**Florida
Power**
CORPORATION

Subject: Crystal River Unit 3
Docket No. 50-302
Operating License No. DPR-72

RESPONSE TO NRC REQUEST
FOR ADDITIONAL INFORMATION

HIGH DENSITY RACK MODIFICATION

TABLE I

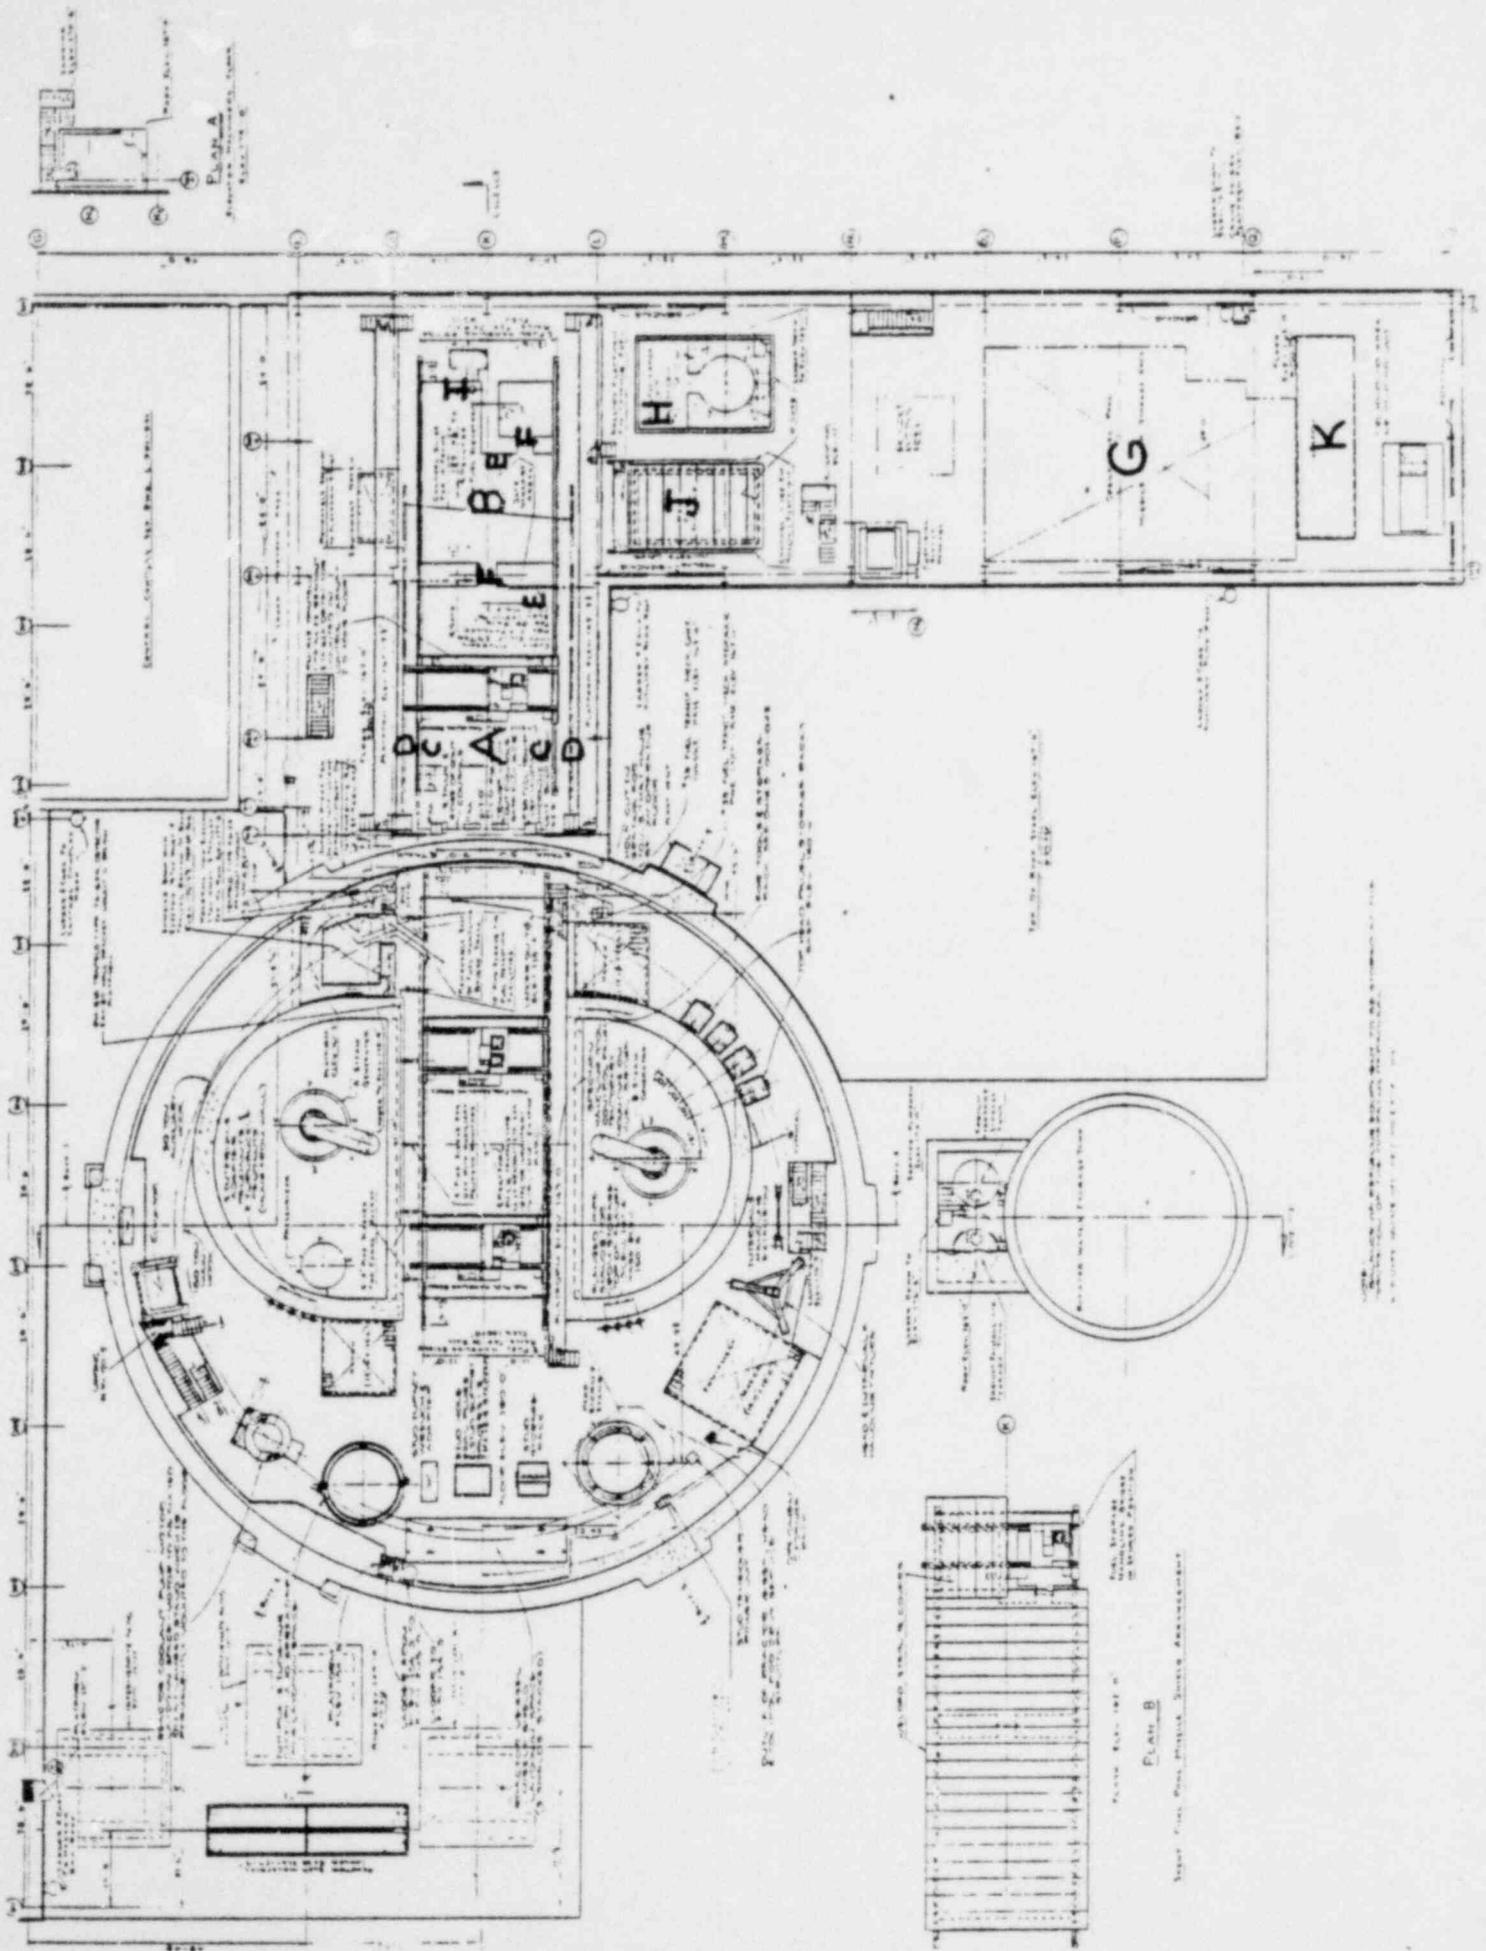
Provide a list of typical loads that might be carried near or over the spent fuel pool. Provide the weight and dimensions of each load. Discuss the load transfer path, including whether the load must be carried over the pool, the maximum height at which it could be carried and the expected height during transfer. Provide a description of any written procedures instructing crane operators about loads to be carried near the pool. Provide the number of spent fuel assemblies that could be damaged by dropping and/or tipping each typical load carried over the pool.

The attached Table I and Figure I identify the loads that might be or are carried over the spent fuel pool. The following is a list of the plant

The utilization of a load list is of no specific merit. The fact that a load size, dimension, weight or configuration is known does not provide sufficient information in regards to the number and extent of fuel assemblies that could be damaged. It is essentially impossible to predict a load's angle of attack and final resting position for each of the above listed loads. However, Technical Specification 3.9.7 requires that loads in excess of 2,750 pounds, except for movement of the missile shield and pool divider gate as necessary for access to the fuel assemblies, be prohibited from travel over fuel assemblies in the storage pool. The restriction on movement of loads in excess of the nominal weight of a fuel and control rod assembly and associated handling tool over other fuel assemblies in the storage pool ensures that in the event this load is dropped (1) the activity release will be limited to that contained in a single fuel assembly, and (2) any possible distortion of fuel in the storage racks will not result in a critical array. This assumption is consistent with the activity release assumed in the accident analyses. The radiological consequences due to the rupture of 208 pins (that of a spent fuel element) at maximum activity has been analyzed and determined to be small and is referenced in the "Safety Evaluation Report."
